PERRY NUCLEAR POWER PLANT UNITS 1 & 2

ENVIRONMENTAL REPORT

**SUPPLEMENT 2
SEPTEMBER 1981**

Perry Nuclear Power Plant
Docket Nos. 50-440; 50-441
Response to Revised ER-OL
Review Questions

PERRY NUCLEAR POWER PLANT
1972 USGS LAND USE/LAND COVER -
LEVEL 2, TEN-MILE RADIUS
PERRY NUCLEAR POWER PLANT
THE CLEVELAND ELECTRIC
ILLUMINATING COMPANY FIGURE 310.02A

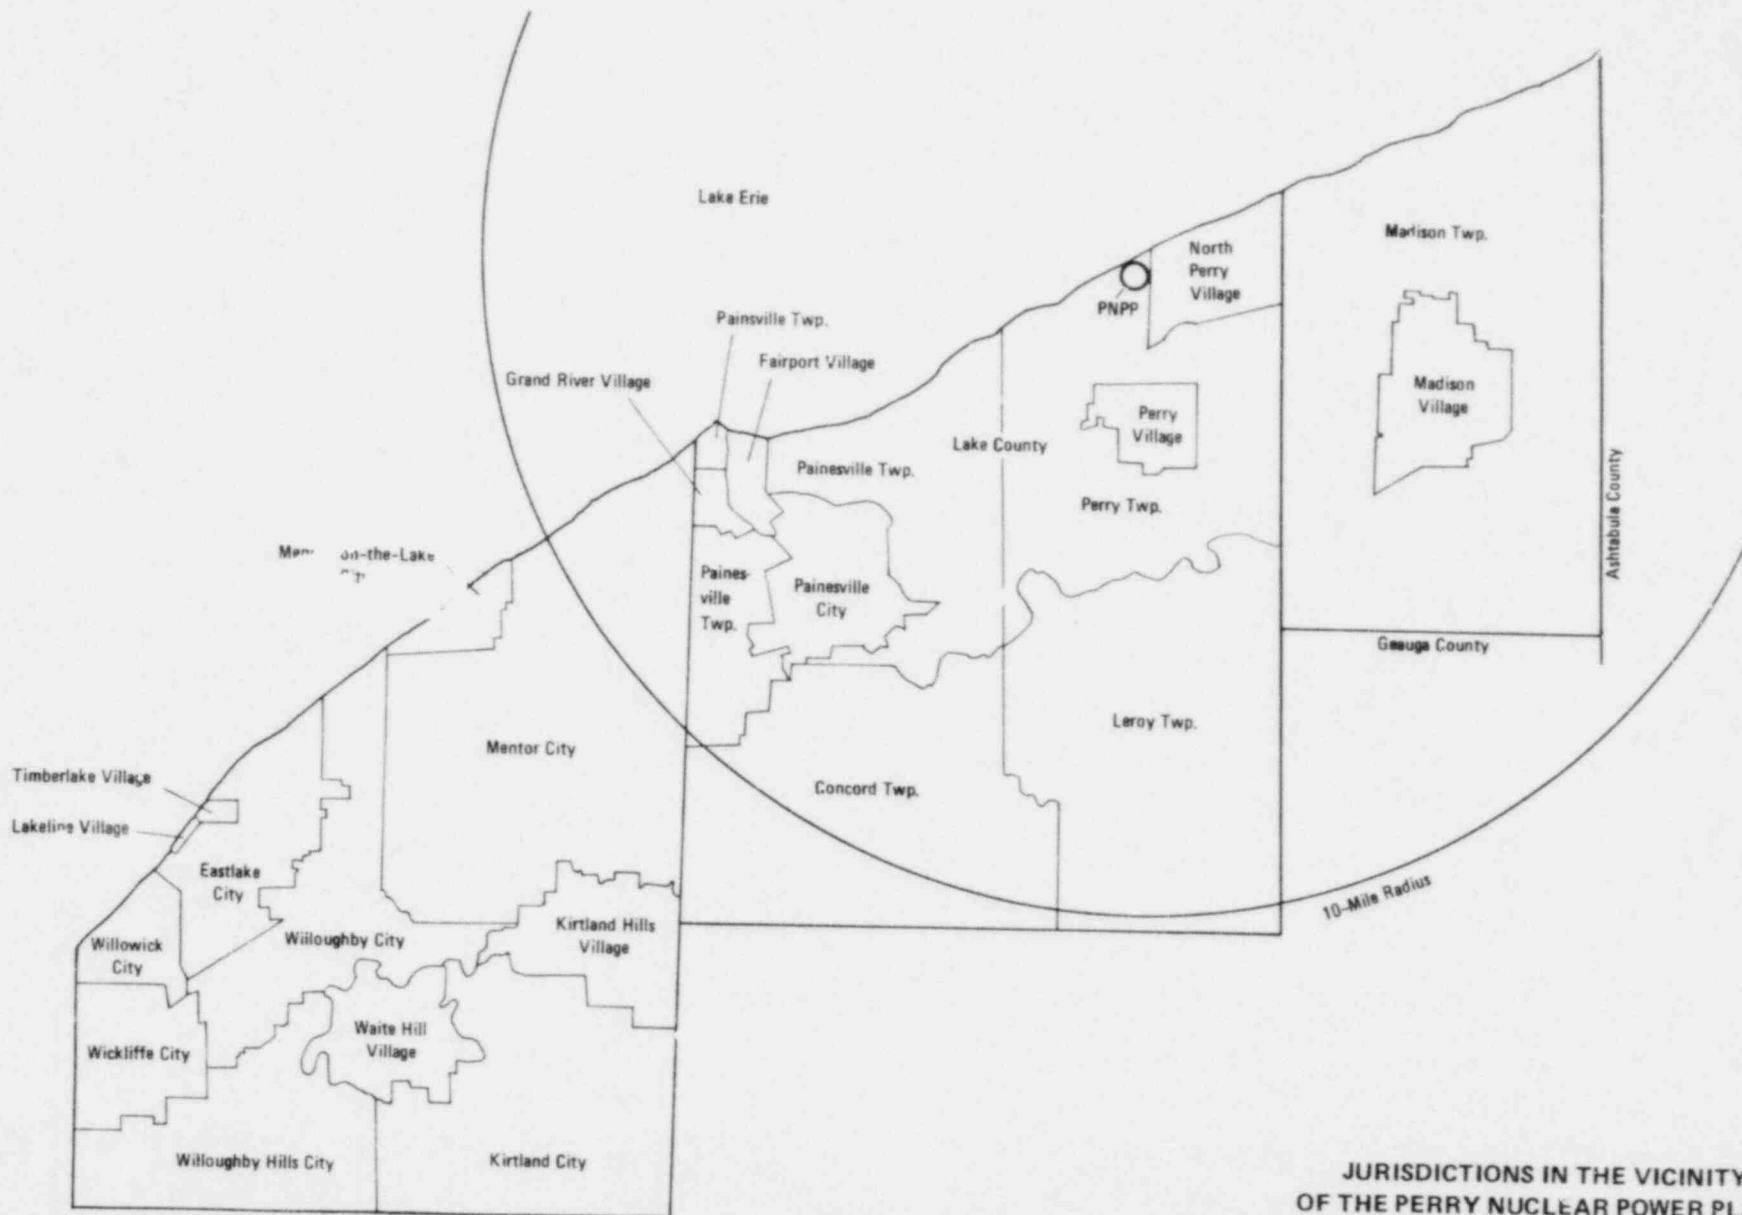
310.02 Update the OL-ER Figures 2.1-18 and 2.1-20, which
(2.1) provides zoning designations and actual and future
 land use plans for a 10 mile radius of the plant.
 Identify any changes in these land use plans that
 may affect the pattern of population growth.

Figures 2.1-18 and 2.1-20 provide land-use information out to 5 miles. Land-use data for the entire State of Ohio are available from the State Department of Natural Resources. A computerized mapping system (OCAP: Ohio Capability Analysis Program) provides land-use according to level 2 of the Anderson system (U.S. Geological Survey Circular 671). The user specifies the center and radius and the computer prints a map describing all of the land use within the specific area. For the purpose of this question, the center is Perry and the radius is 10 miles. The computer also presents summary statistics for the areas chosen. The data for OCAP have been obtained from 1972 USGS topographic maps (and in some cases more recent survey flights); the results give a general idea of the predominant land uses in the vicinity of the plant. The data are shown on Figure 310.02A.

FIGURE 310.03A

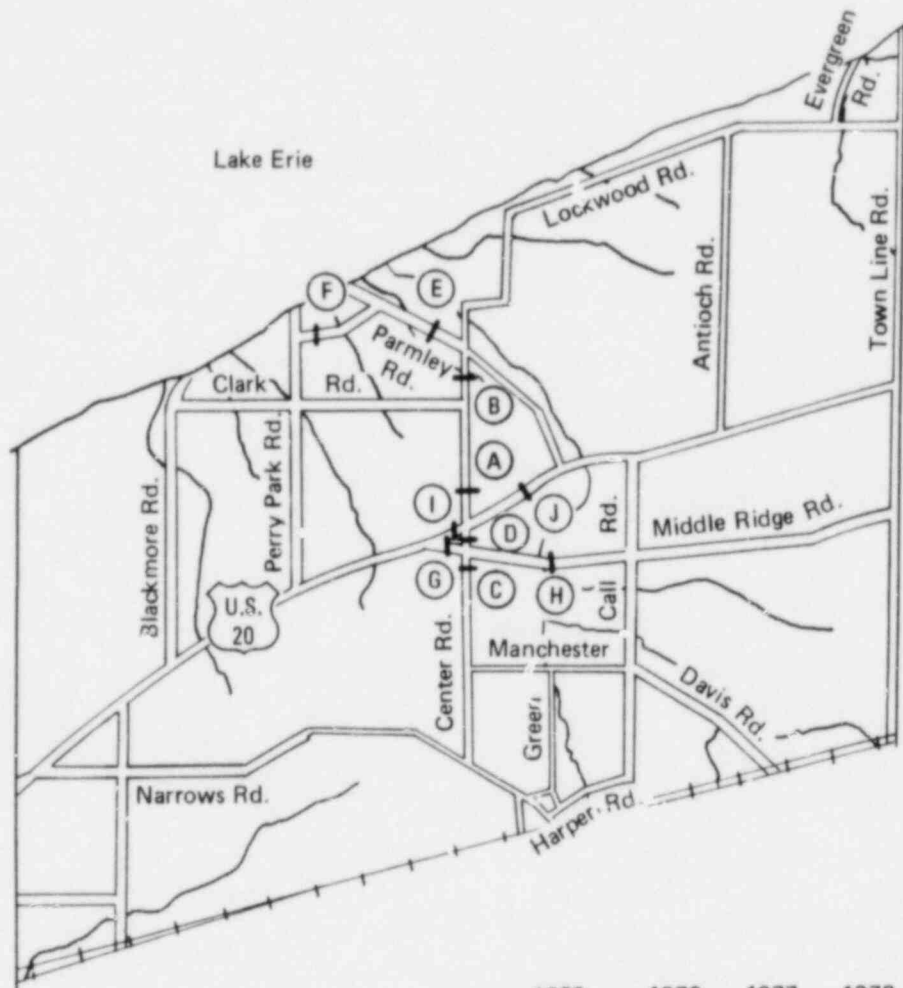
310.03 Identify any places where traffic congestion or problems
(2.1) of interference with patterns of local traffic might
be anticipated due to plant operation or maintenance.
Traffic counts of major access roads to the plant
site would be useful to support your position.

Construction of the PNPP has caused substantial congestion at a number of points in the area. The heaviest congestion occurs on Center Road between U.S. 20 and the plant, on Parmley Road between Perry Park Road and the plant, and on Middle Ridge Road, east and west of Center Road. As Figure 310.03A indicates, average daily traffic (ADT) on Center road north of U.S. 20 increased from just over 700 in 1972 to about 4000 in 1980. Much of this increase can be attributed to the Perry Plant, which employed over 3000 workers in 1980. On Parmley Road between Perry Park Road and Center Road, traffic increased over 100 percent between 1972 and 1980. ADT on Middle Ridge Road east and west of Center Road experienced a similar increase as drivers are using the road to avoid congestion elsewhere. The data in Figure 310.03A is a summary of information mainly obtained from Douglas T. Harrison, Lake County Engineer⁽²⁾, who notes in his letter that examination of the data suggests that about "three-fourths of Center Road traffic can be attributed to Nuclear Plant Construction and ancilliary activities."

Thus, the congestion on Center, Parmley, and Middle Ridge Roads will continue and increase slightly until 1986. During this year, as the construction work force begins to decline, congestion will abate. In 1989, when only operating workers are present at the plant, congestion should decrease dramatically. It will remain at a low level throughout the rest of the plant's operation.

THE CLEVELAND ELECTRIC
ILLUMINATING COMPANY
FIGURE 310.04A

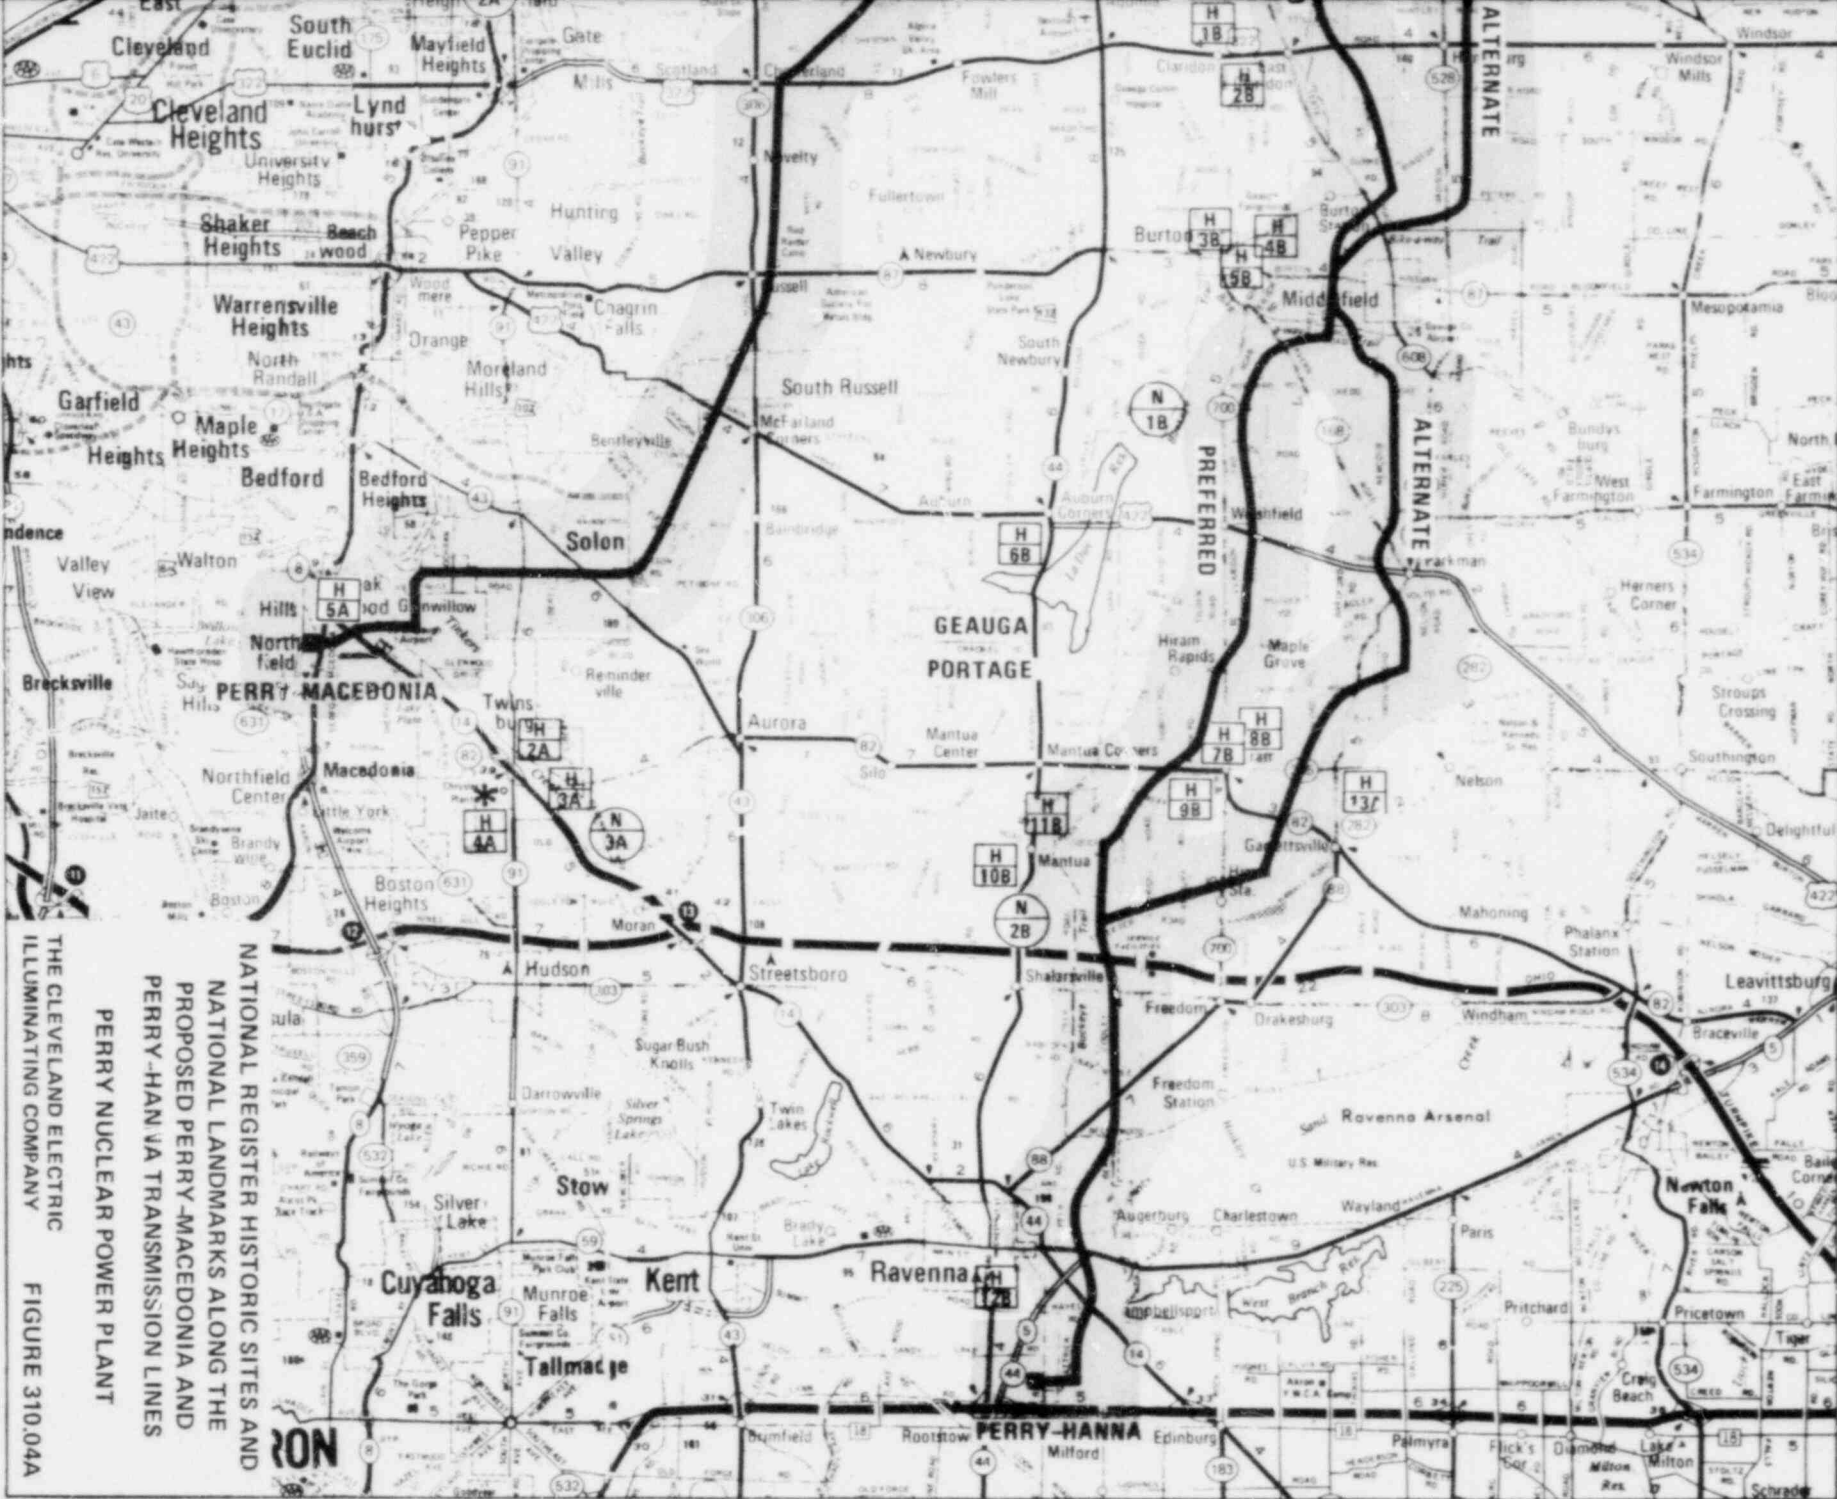
310.04 Tables 2.6-1 and 2.6-2 in the ER-OL describe the cultural
(2.6) resources within the area of the PNPP site listed
 in the National Registers of National Landmarks and
 of Historical Places. Provide such a list of resources
 within 2 km of the transmission corridors. Include
 in the listing sites nominated for the Register.

Figure 310.04A is a map of the area in which the site and the proposed transmission lines are located. The two proposed transmission lines, Perry-Hanna (PH) (preferred and alternate) and Perry-Macedonia (PM), are indicated on the figure. Also indicated on the map are the National Register Historic Sites and Natural Landmarks which are near these lines. Historic sites are labeled "H" and Natural Landmarks "N." Those along the Perry-Macedonia Line have the subscript "A" followed by a number and those along the Perry-Hanna Line have the subscript "B" followed by a number. In the description which follows, if a resource near a transmission line is within 2 km of the line, the estimated distance is given; otherwise it is indicated to be greater than 2 km away. The letters "P" and "A" following the PH refer to preferred and alternate routes. There is only one proposed route for the PM line. It is the same as the PH alternate from the start at North Perry Until just north of the Geauga County-Lake County line where the lines split. From this point, PM goes southeast and PH (P and A) goes south (see Figure 310.04A).
